LUPIN MINES INCORPORATED

2020 Updated Final Closure and Reclamation Plan

Technical Comment Responses

Figure 1 – Locations of Contaminated Soils to be excavated. Issued 2020-11-30

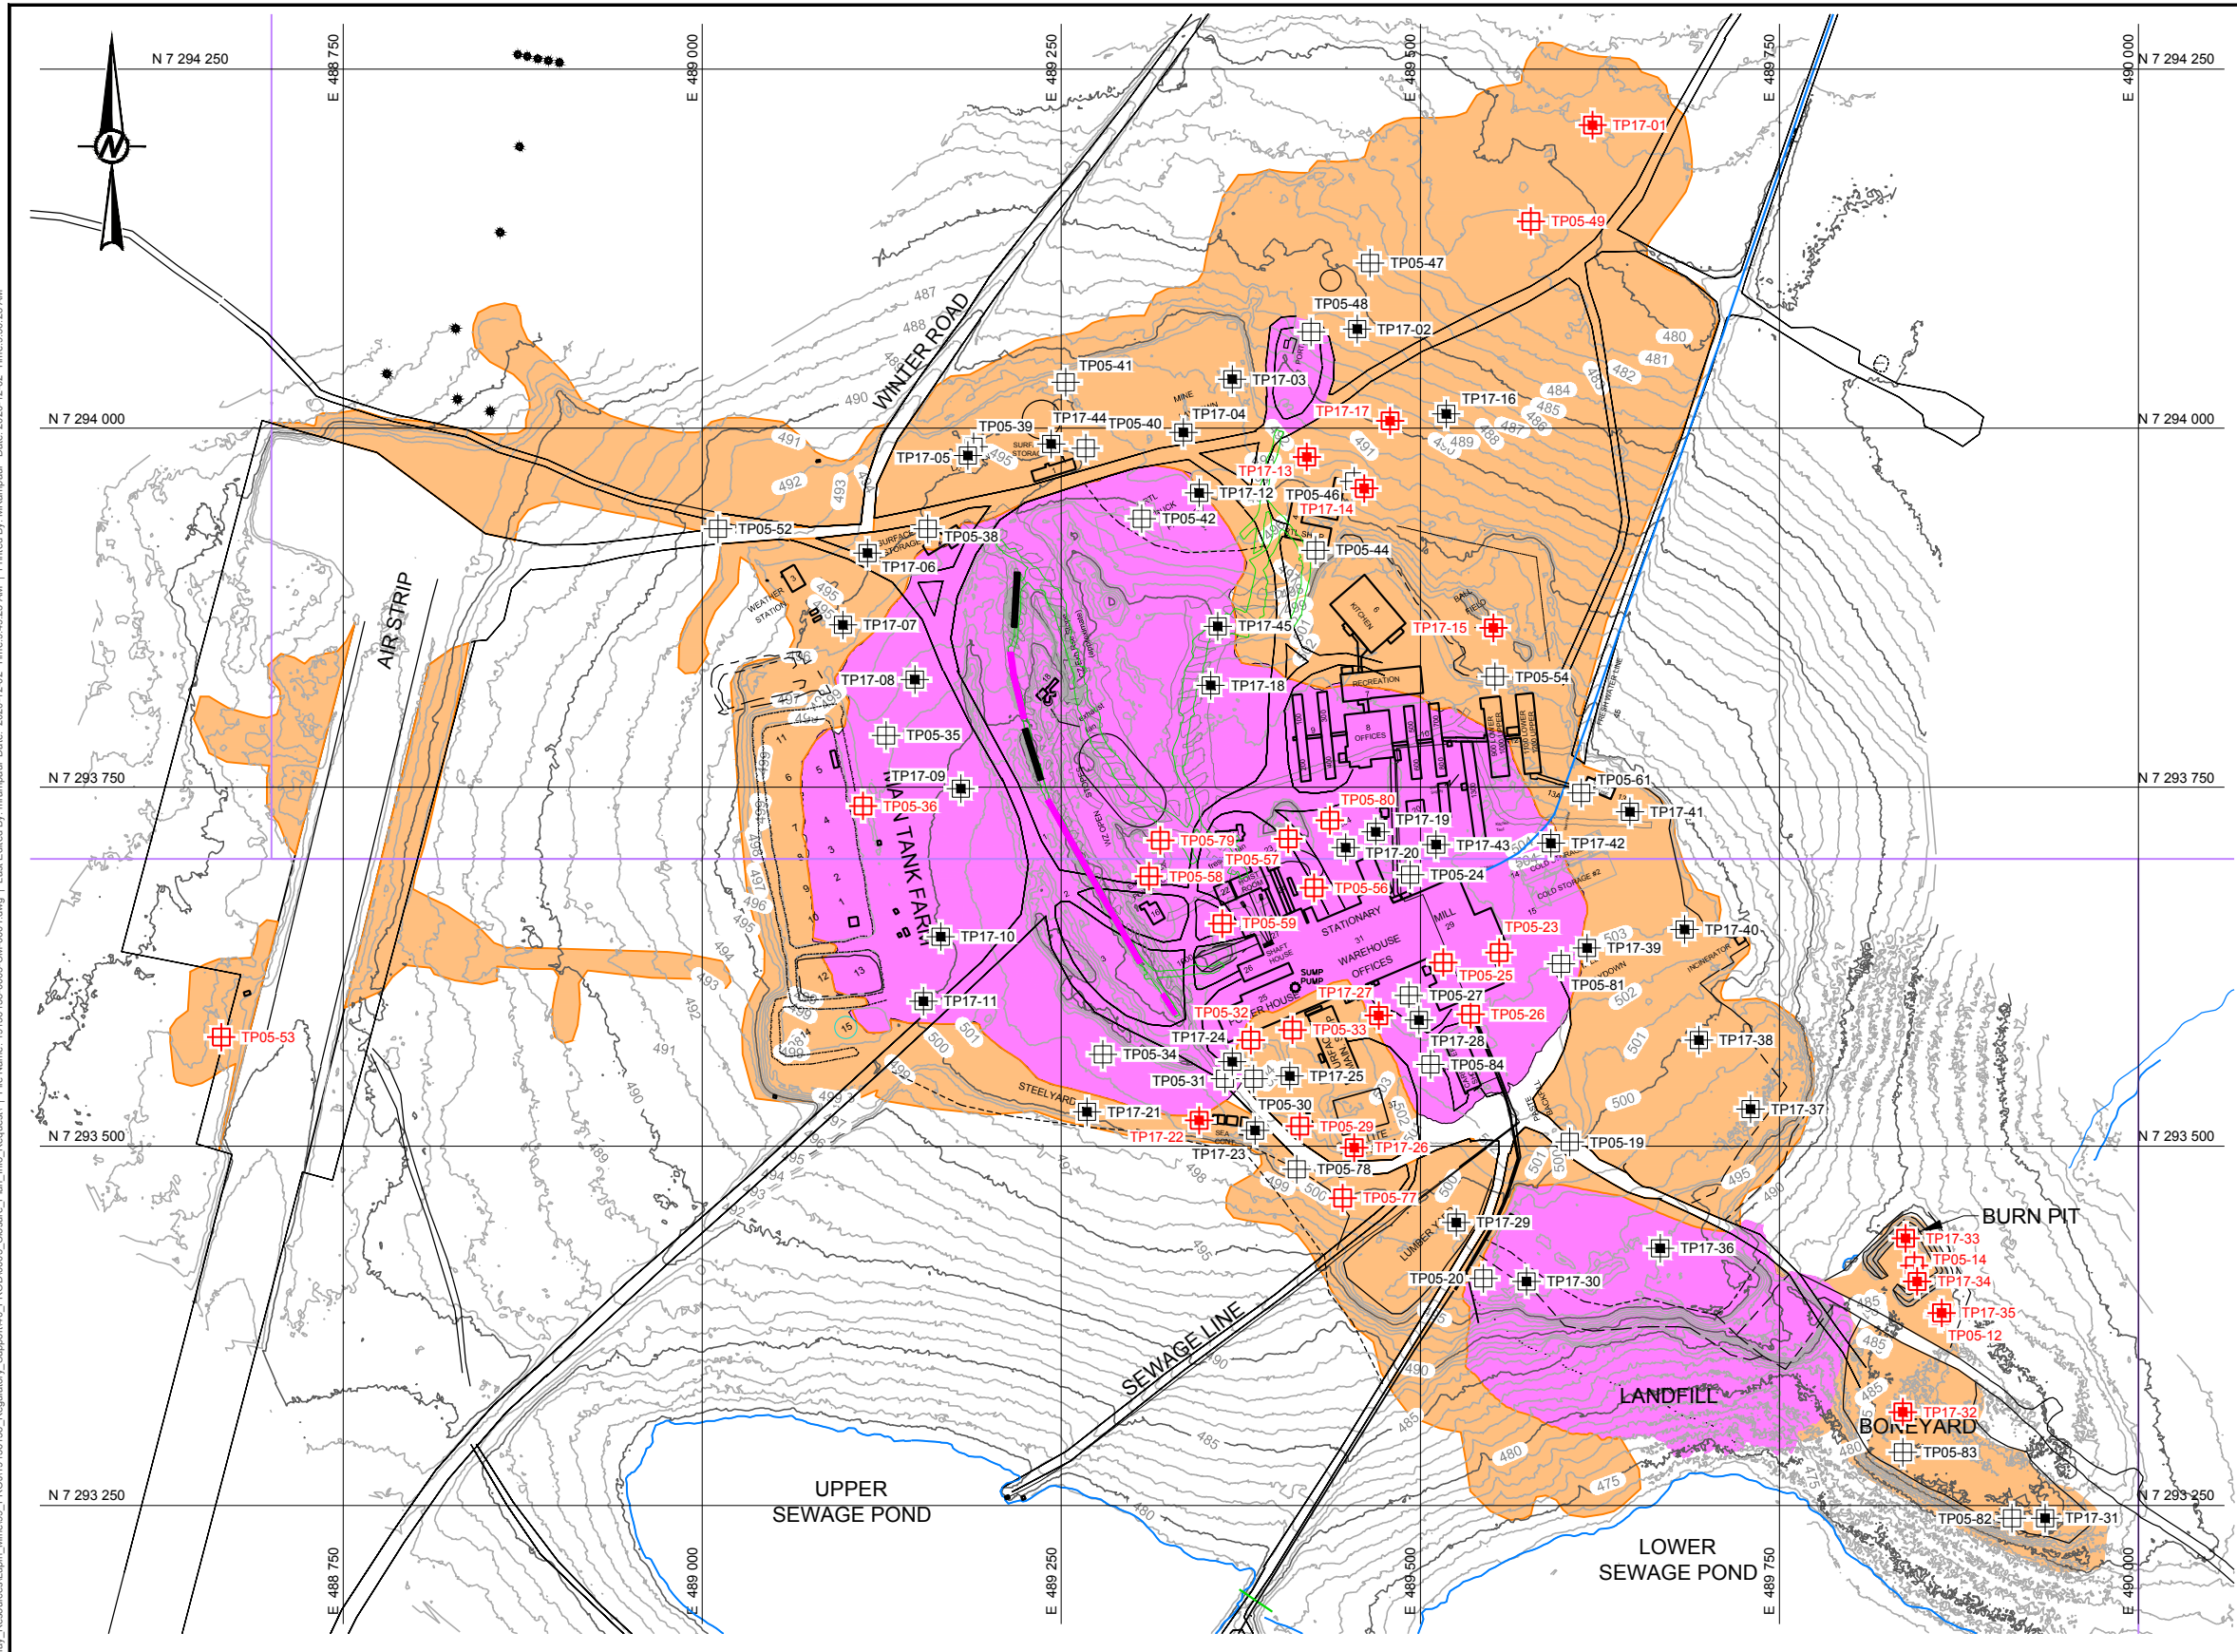
No drawings were provided in the R1 FCRP document identifying the location and extent of the areas with heavily impacted arsenic or PHCs requiring excavation. In the absence of a drawing providing this information it is difficult to confirm that all of these impacted materials have been removed from these locations before consolidating the waste rock at the mill site.

CIRNAC recommends that LMI provide a detailed site plan that identifies the location and estimated extent of heavily impacted arsenic soils, and PHC impacted soils that are expected to be excavated and placed underground. CIRNAC also requests that LMI clarify how it will confirm that these materials have been removed prior to waste rock re- grading and cover placement.

Further to the ESA completed in 2006 and updated in the 2017 Updated Phase 1 & II Environmental Site Assessment completed by Golder, a detailed site plan indicating the locations of heavily impacted arsenic soils and PHC impacted soils that will be excavated and disposed underground is attached (Figure 1). The extents of the excavations will be determined in the field through the completion of field screening and confirmatory soil sampling. LMI will confirm the removal of these materials through the implementation of the contaminated soils quality assurance / quality control (QA/QC) plan outlined in Appendix C2 of the Post Closure Monitoring Plan due to the NWB on 9 April 2021 in accordance with Part J, Item 13 of the Licence.
